**BEFORE THE PUBLIC UTILITY COMMISSION
OF OREGON**

LC 82

2023 Integrated Resource Plan and
Clean Energy Plan.

**ROUND 1 COMMENTS OF
RENEWABLE NORTHWEST**

Figure 2: Comparison of NG forward price curves found in CPUC & PAC 2023 IRPs

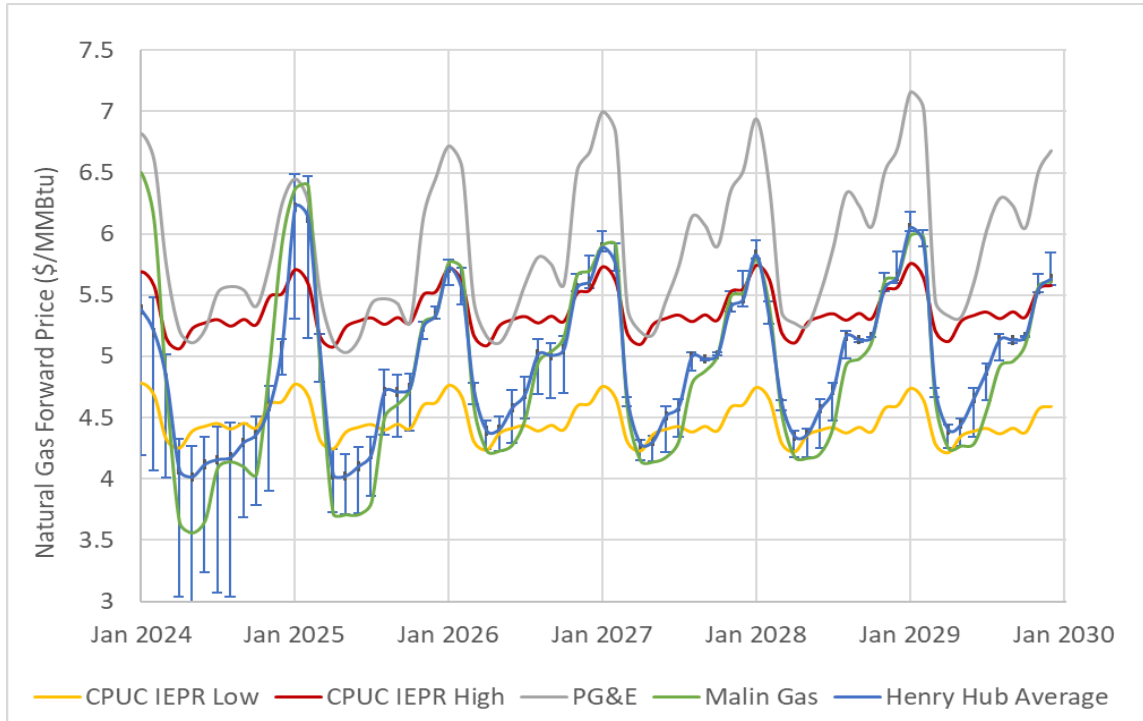
The forward prices used in PacifiCorp’s IRP are forecasted Henry Hub trading prices. This forecast is “based on prices observed in the forward market and on projections from third-party experts.”⁵⁵ The Henry Hub average is standard for North American natural gas fuel price projections, but prices at trading hubs may differ, as noted in the IRP.⁵⁶ In addition, PacifiCorp considers five different gas price scenarios for its modeling, which represent different market conditions as well as potential CO2 emission pricing scenarios. Figure 2 visualizes a few key comparisons for future gas prices. The Henry Hub forecast, which is the primary forecast used within the IRP, matches closely with forecasted pricing at the Malin Gas trading hub, which is located within PacifiCorp’s service area. The forecasted price at the PG&E hub is significantly higher, however, especially during summers, and year-round starting in 2026. The CPUC IEPR⁵⁷ forecasts project a much less pronounced seasonal variation in natural gas pricing. The “high” forecast in the 2023 CPUC IEPR is much higher than the Henry Hub forecast over summer but matches closely with the projected winter peak price. Conversely, the “low” IEPR projection is much lower than the Henry Hub forecast during the winter peak but matches closely with the forecasted low prices in spring (Figure 2).

Figure 3: Comparison of unsubsidized hydrogen (H2) fuel costs from variety of sources

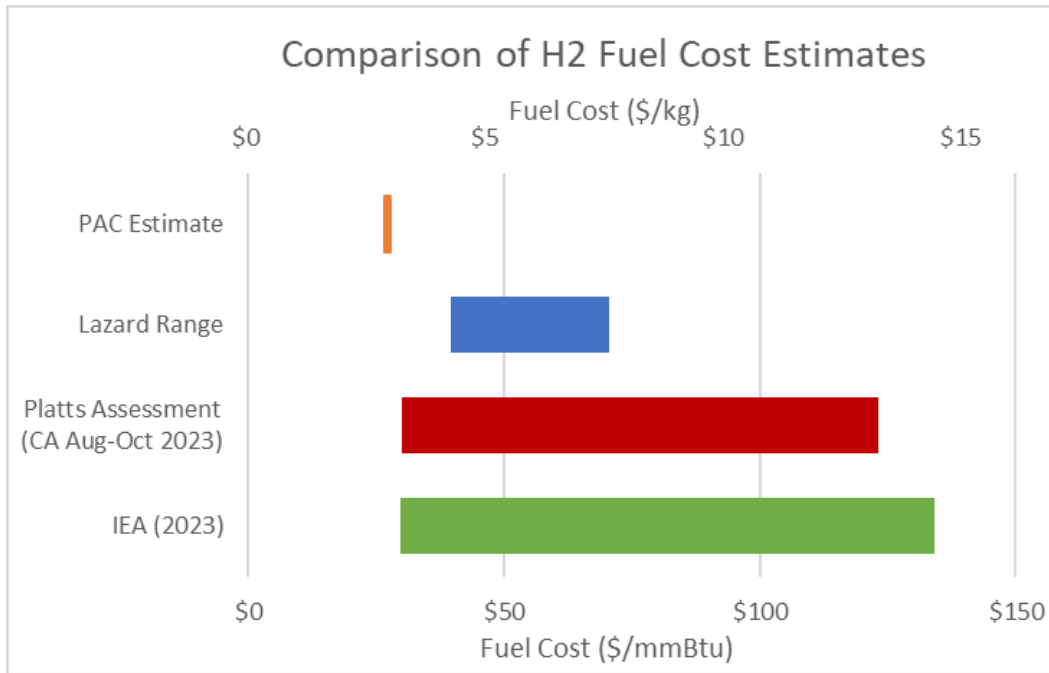
fuel cost estimate for green hydrogen and specify whether the price includes an assumed PTC. In addition, this is merely a spot estimate for hydrogen price, and it is currently unclear what assumptions PacifiCorp makes about the price of hydrogen in the future. Given the wide range of possibility for hydrogen price, and given market volatility as seen in recent market data, we believe it is important that forward hydrogen cost projections reflect a wide range of possibility, particularly if PacifiCorp does not have plans to actively solicit long-term contracts for firm, zero-emissions hydrogen in the locations and quantities it needs.

Figure 4: Comparison between NG peaker plant costs in the PacifiCorp IRP and Lazard

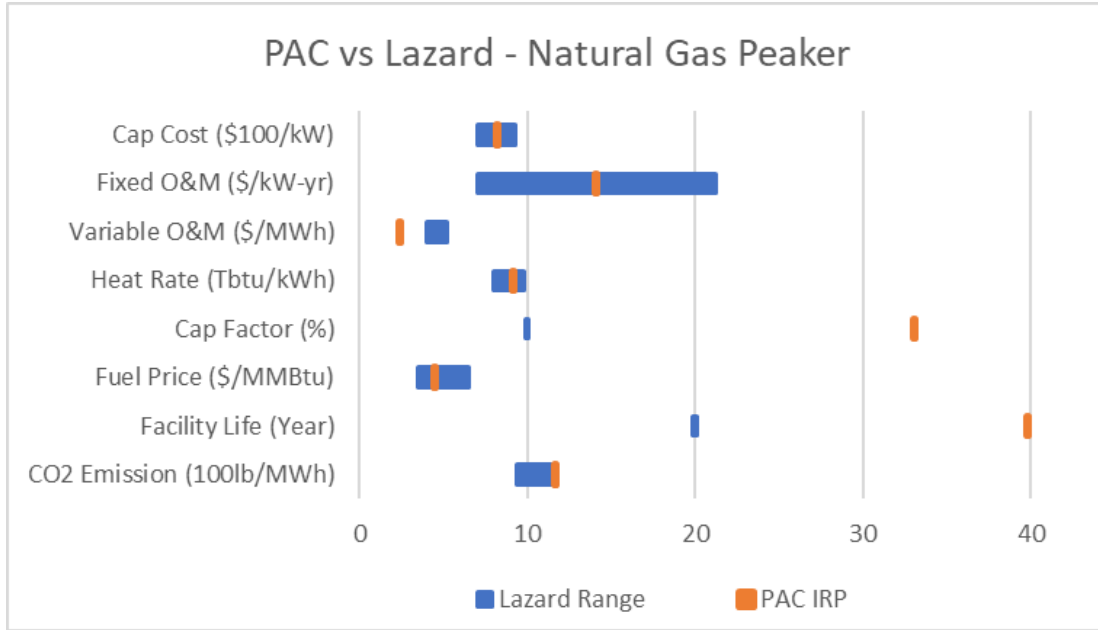
PacifiCorp details resource cost assumptions for the IRP in Table 7.2. For the purposes of this comparative analysis, we are considering the resource described as “SCCT Frame ‘J’ x1.” While most estimates related to this peaker plant are within range of those seen in Lazard’s most recent cost estimates,⁶² there are several estimates that lie outside of the expected range. PacifiCorp assumes lower Variable Operations and Maintenance (O&M) costs, longer facility life, and much higher capacity factors than the ranges presented in Lazard’s analysis (See Figure 4). Together, these assumptions result in a levelized cost of \$78.36/MWh, which is far below Lazard’s lower bound of \$115/MWh. The assumption of a 33% capacity factor is responsible for most of this discrepancy.

Figure 5: Comparison between hydrogen peaker plant capital costs from the PacifiCorp and CPUC IRPs and Lazard

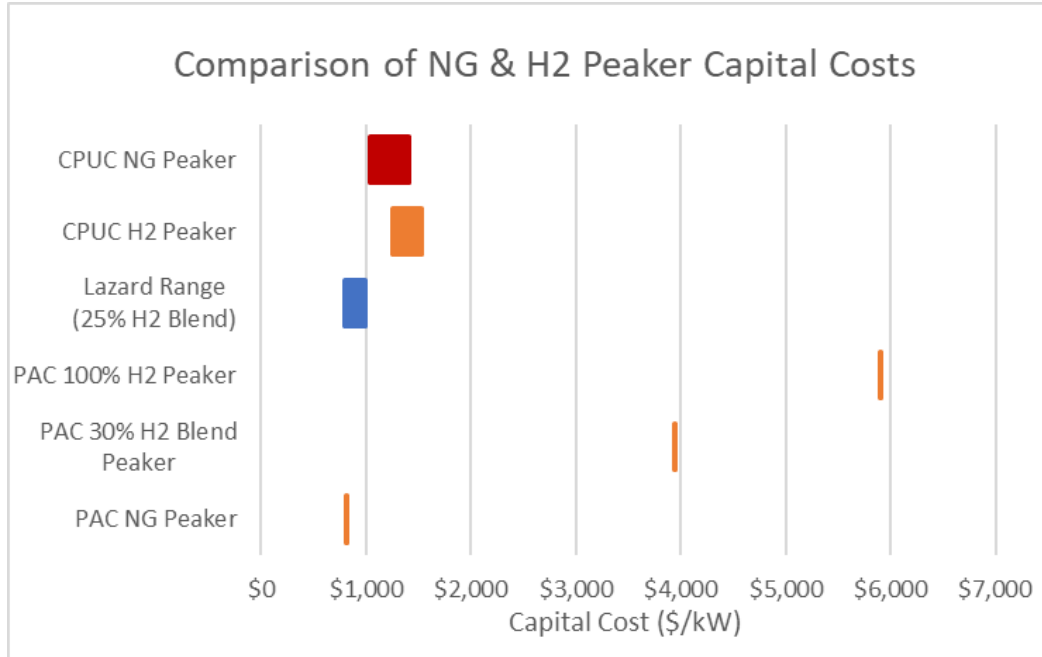
In Table 7.2, PacifiCorp estimates that 100% hydrogen peaker plants will have capital costs at or above \$5,900/kW, and that plants with 30% hydrogen blends will cost close to \$4,000/kW. There is no justification or explanation for this number, and given how much higher it is than other estimates, we request that PacifiCorp provide a detailed breakdown or specific source for that estimate. The CPUC estimates capital costs ranging from \$1250-1530/kW for new hydrogen combustion turbine plants. Lazard’s levelized cost estimates for natural gas/hydrogen blend plants imply very similar capital costs to their natural gas peaker plants, which it estimates have capital costs below \$1000/kW (Figure 5).

Figure 6: Comparative Analysis of Solar Photovoltaic Overnight Capital Cost Assumptions^{75,76}

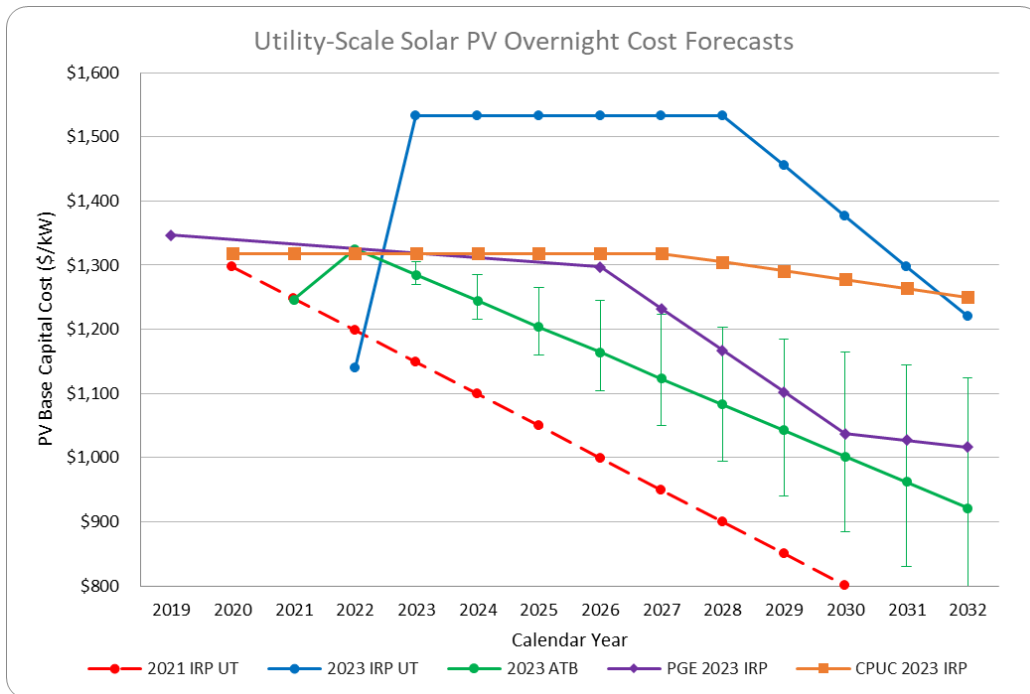
Solar resources, after many years of decline, are estimated to increase in cost by 34% beginning in 2023, with a flat cost projection to 2028, and rapid cost reductions through 2032.⁷¹ The extended cost increase is driven by the assumption that it will take until 2029 for new and existing manufacturing capacity to address back-ordered and on-going panel demand. The projected cost of \$1,533/kW for a 200MW installation in Utah far exceeds the estimate of \$1,074 provided by the WSP study,⁷² and the explanation for this nearly 50% increase in modeled costs is not fully supported in the text. The best comparisons predict significantly lower prices than those assumed in the PacifiCorp IRP and generally assume declining cost curves. PGE’s IRP⁷³ estimates overnight capital costs of \$1,347/kWac in 2026 with declining costs from 2026 through 2030. The CPUC assumes \$1,318/kWac for 2022 to 2027, with declining costs thereafter.⁷⁴ The 2023 NREL ATB reflects changing market conditions with price increase in 2022 to \$1,325/kWac, but predicts steadily declining capital costs in each following year.

Figure 7: Comparative Analysis of Land-Based Wind Overnight Capital Cost Assumptions^{83,84,85,86}

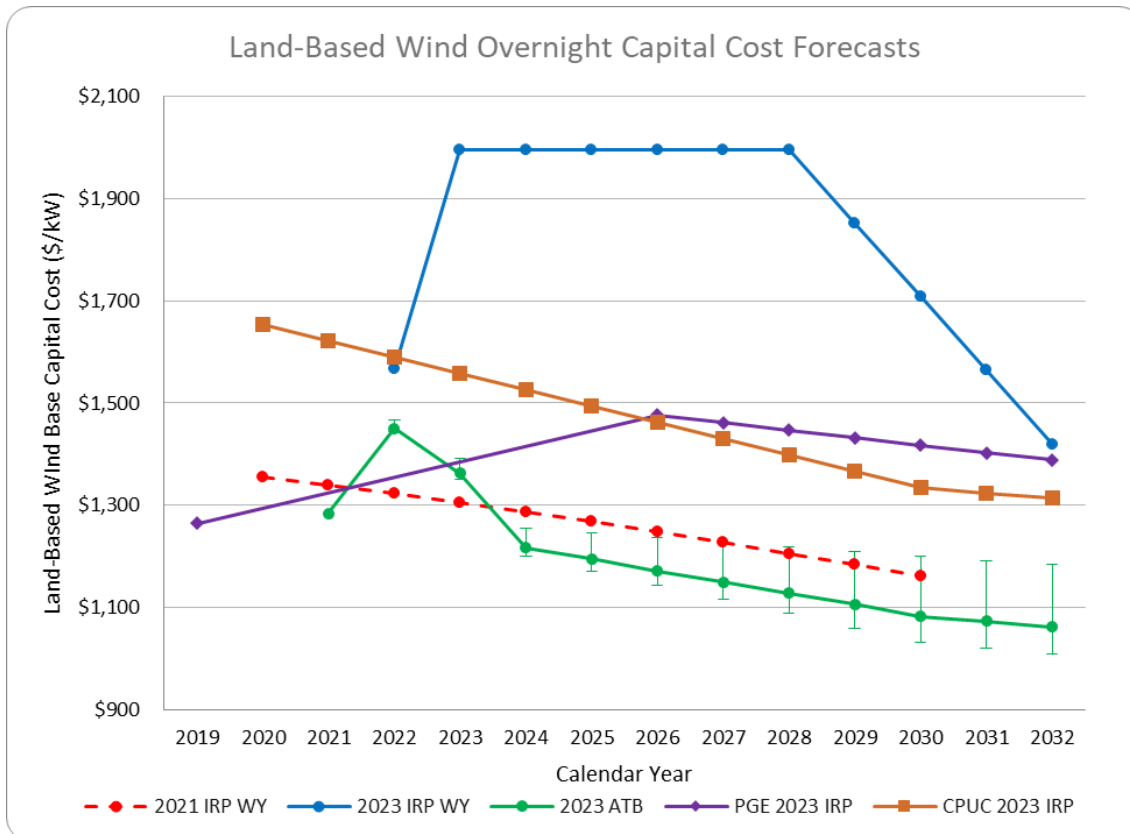
Wind resources, like solar, are also assumed to sustain high prices through the late 2020s.⁷⁸ Similar to photovoltaics, PacifiCorp notes that it combines its market experience with the WSP analysis to inform wind cost assumptions,⁷⁹ but does not provide a clear articulation of how these modifications were determined.

Figure 8: Comparative Analysis of Offshore Wind Overnight Capital Cost Assumptions⁸⁸

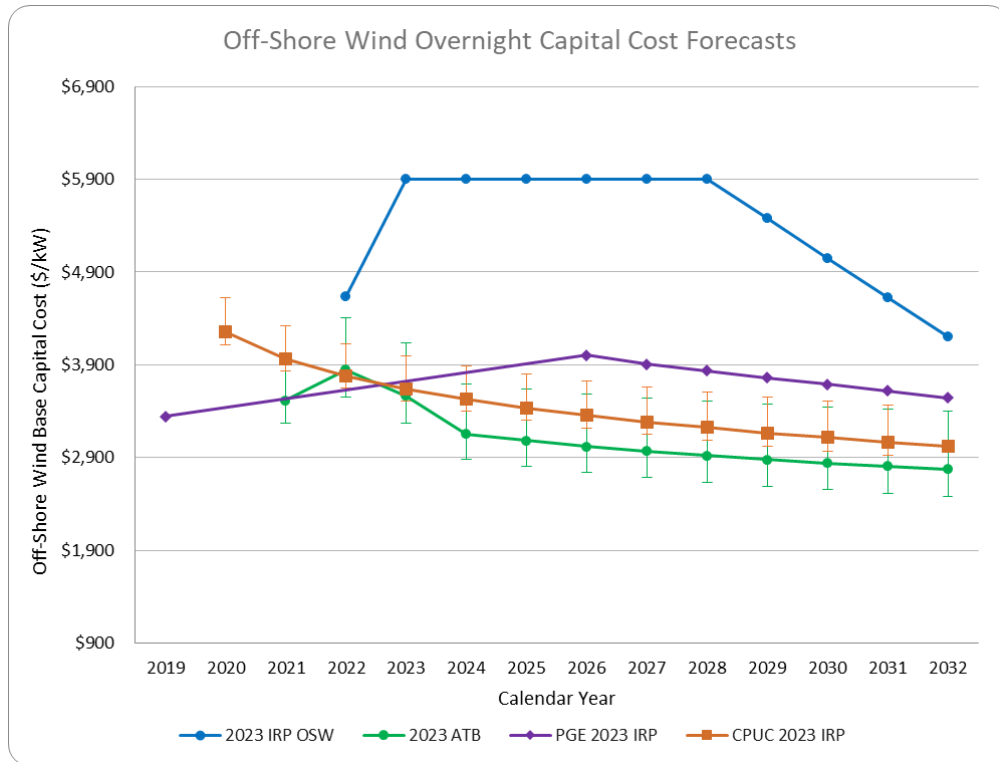
RNW appreciates the addition of offshore wind to PacifiCorp’s cost analysis in this IRP cycle, however, as with other resources, RNW is concerned by the significant differential between PacifiCorp’s cost assumption and comparable benchmarks. Offshore wind, like solar and land-based wind resources, is assumed to have significant cost escalation into 2023 which does not decline until 2029, one year after offshore wind becomes available for selection by the model. PacifiCorp estimates overnight costs of \$5,900/kW,⁸⁷ considerably above PGE’s assumption of \$4,000/kW in 2026 and the CPUC’s assumption of \$3,600/kW in 2023.⁶⁷ NREL’s 2023 ATB estimates a high price of \$3,849/kW in 2022, followed by a rapid decline to \$3,155/kW in 2024. PacifiCorp’s uniquely high view of offshore wind costs make it highly unlikely that the resource would be selected by the model, preventing robust

consideration of transmission and market development needs which must be triggered in the near-term to facilitate the resource’s development in the late 2020s.

Figure 10: Comparative Analysis of Battery Energy Storage System Overnight Capital Cost Assumptions⁹⁹

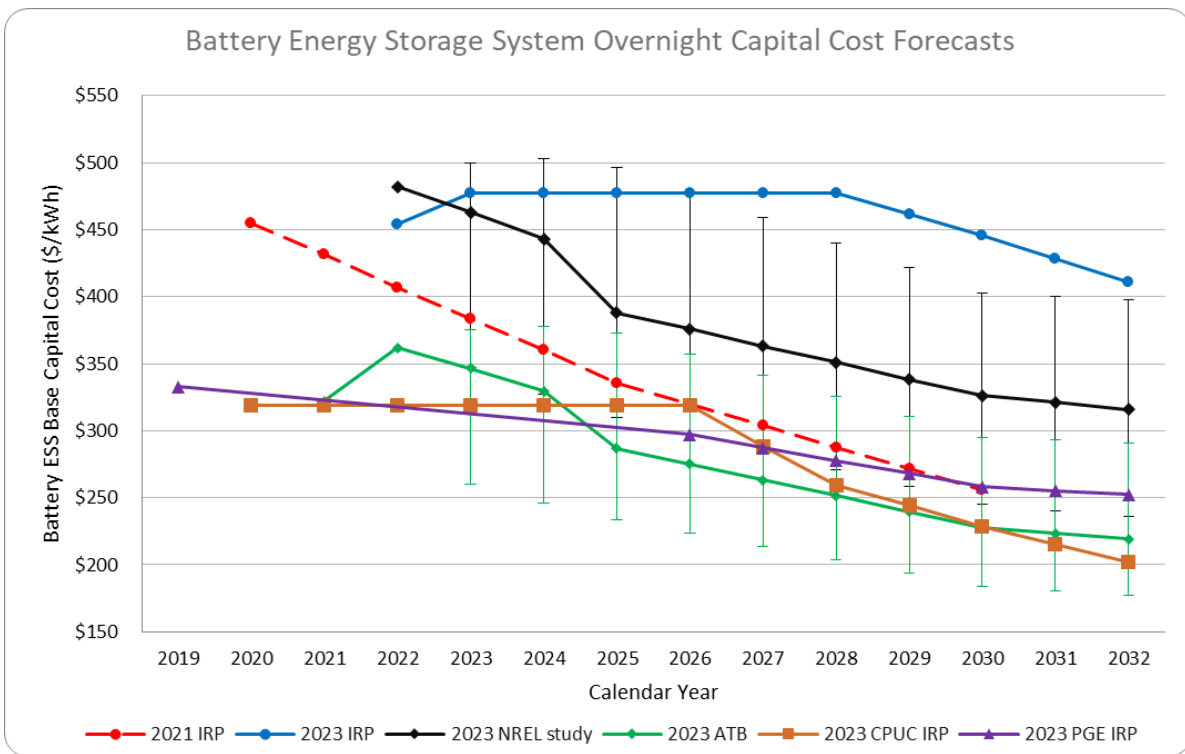
capital costs of the energy storage system (\$454 and \$477/kWh). Again, PacifiCorp projects no cost declines until 2029.⁹⁵ Again, this assumption seems at odds with cost estimates from PGE of \$297/kWh in 2026.⁹⁶ The CPUC estimates that capital costs for 4-hour Li-Ion batteries remain constant at \$319/kWh until 2026, then continue to decline.⁹⁷ NREL’s 2023 ATB includes costs above \$350/kWh in 2022 that decrease to below \$300/kWh by 2025 in the mid case.

NREL released a June 2023 cost update for utility-scale batteries,⁹⁸ which has overnight capital costs above \$450/kWh for 2022 and 2023. The high-end estimates in the refreshed NREL study through 2026, however, decline on a faster track than those in PacifiCorp’s analysis, which may be impactful for late 2020s resource selection. NREL’s study refresh assumes a steadily decreasing capital cost that falls below \$400/kWh in 2025 in the “mid” case.

Figure 15: Reported FOT Purchases Relative to FOT Limits

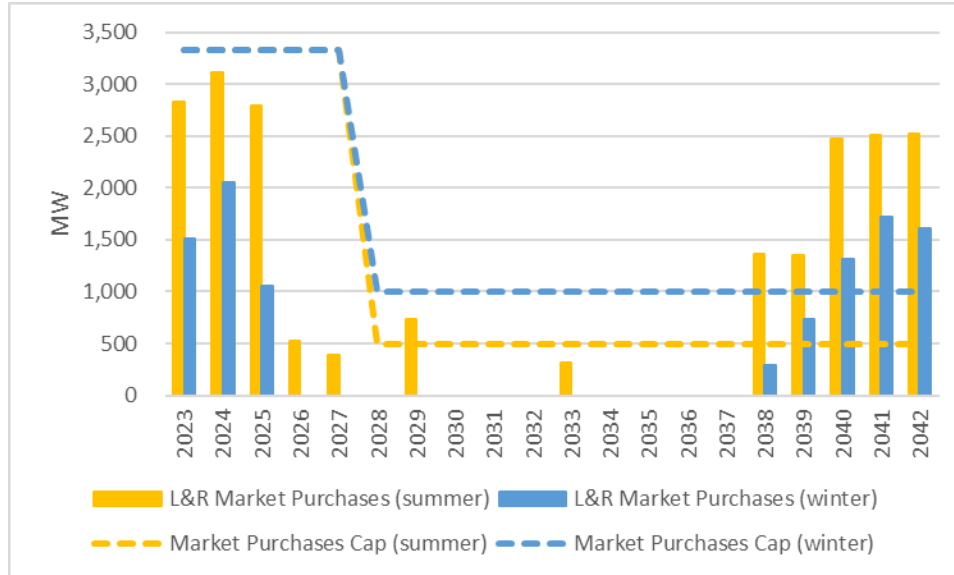
PacifiCorp’s 2023 IRP filing shows a heavy reliance on FOTs for both the summer and winter season in the near-term horizon. Figure 15 below, summarizes the volume of market transactions listed in Tables 9.32 and 9.33 for the summer and winter seasons, respectively. The company has a need in the near term for ~3000 MW of market purchases in the summer and 1000-2000 MW of purchases in the winter. These market positions constitute a material share of the overall portfolio supply, making up 20-25% in the summer and 10-20% in the winter. The preferred portfolio shows little to no need for market transactions between 2026-2037, but they return in 2038. Moreover, the volumes reported for the tail end of the planning horizon exceed the post-2027 market limits as defined in Table 5.8.¹⁴⁸ Although RNW acknowledges PacifiCorp publishes the seasonal L&R tables for reporting purposes only and doesn’t reflect the actual volume of market transactions (which are calculated by PLEXOS), RNW flagged it given the magnitude of the discrepancy.¹⁴⁹ As a result of the large gap between the allowed and reported values, RNW finds it difficult to accurately interpret the meaning of the L&R tables and is concerned that this may be indicative of a material error present in PacifiCorp’s reliability modeling process.

Aside from confusion over the limits on allowed market purchases, RNW views PacifiCorp’s estimates for the maximum limit on available FOTs as problematic because they aren’t supported by a comprehensive regional modeling exercise. Although RNW appreciates PacifiCorp’s literature review of multiple regional reliability studies and believes they provide helpful context on interregional matters, RNW doesn’t view this review as an adequate substitute for a quantitative assessment on regional market availability, especially given the size of the company’s dependency on market transactions in their preferred portfolio.¹⁵⁰ As already acknowledged by PacifiCorp, regional markets are likely to experience increasing uncertainty in both depth and availability due to environmental policies and regional market initiatives, which increases the importance of hedging against the continued risk of high market reliance in the future.¹⁵¹
